HADITHA DAM PERIMETER SECURITY HADITHA, IRAQ

SUSTAINMENT ASSESSMENT

SIGIR PA-09-192
APRIL 13, 2010

SUBJECT: Report on the Haditha Dam Perimeter Security, Haditha, Iraq (SIGIR Report
Number PA-09-192)

Figure 2. Contractor's design of typical fence section
(Courtesy of GRC)

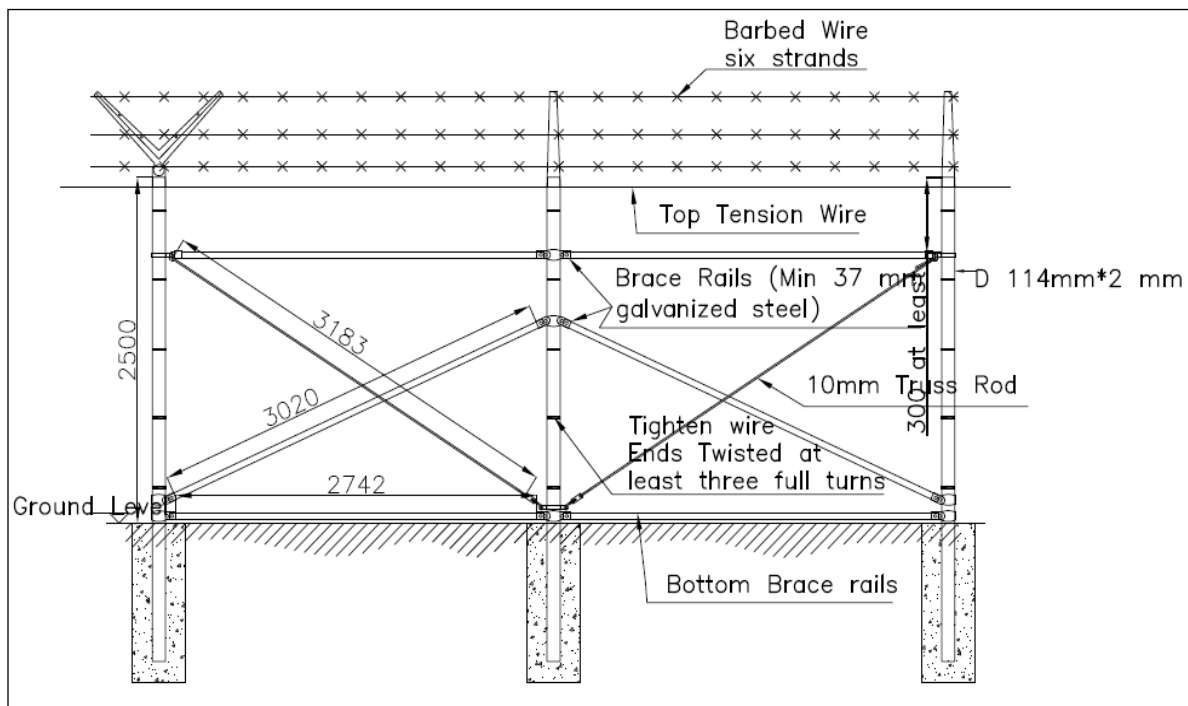
The contractor attached the chain link fabric to the fence posts with steel bands at 32 inches on center. The attachment did not conform to the 15 inches on-center requirement of the USACE standard drawings for a security fence, and was not consistent with the 18 inches on-center indicated on the contractor’s drawings.

The fence brace rails were different dimensions than shown on the contractor’s drawings. The brace rails were attached to the pull post approximately 36 inches above the post base, instead of 58 inches as shown on the contractor’s drawings. The difference will affect the ability of the brace panel to resist tension from the chain link fabric.

The concrete anchorage for the fence posts was approximately 8 to 12 inches deep (Site Photo 6), which was inconsistent with the contractor's design drawings that showed a 45 inch depth for a typical line post. The configuration of the concrete anchorage was not consistent with the contractor's design plans and tapered from approximately 16 inches in diameter at the top to 8 inches in diameter at the base of the post, instead of the required uniform diameter of 16 inches. In addition, the anchorage did not cover the end of the post as shown in the design drawings, which will allow for increased corrosion of the post.

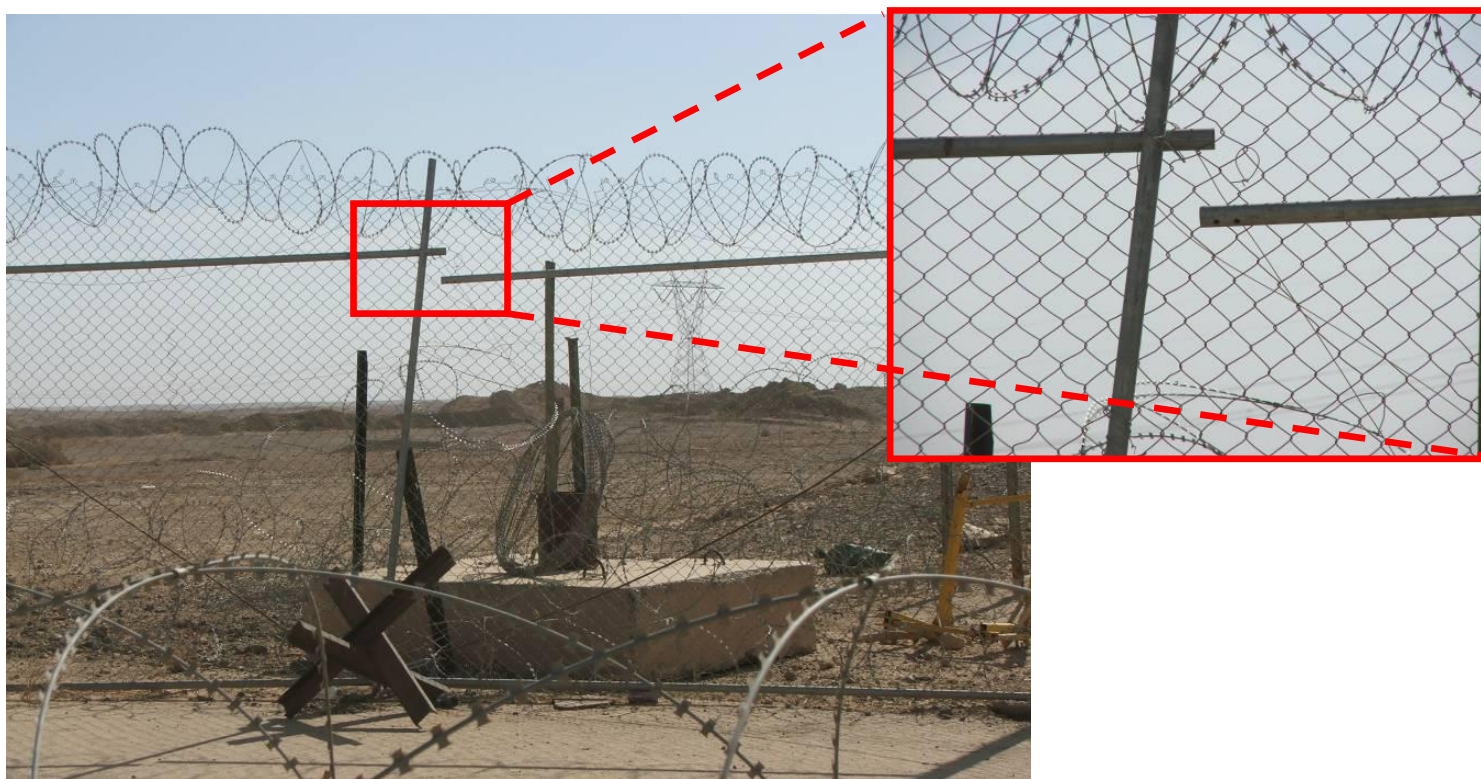
The entry point was constructed completely opposite of the contractor's submitted design plans. The contractor's plans indicated a reasonable method of controlling entry to the facility by using "Jersey" barriers and a lifting gate to slow vehicles prior to reaching the security fence. However, as constructed, vehicles first reach the swing gate in the security fence. After entering the secure area, vehicles are then confronted with the lifting gate, and finally directed through the chicanes into the facility. This configuration contributes little to force protection and allows vehicles to approach the secure area without any method to control speed or direction.
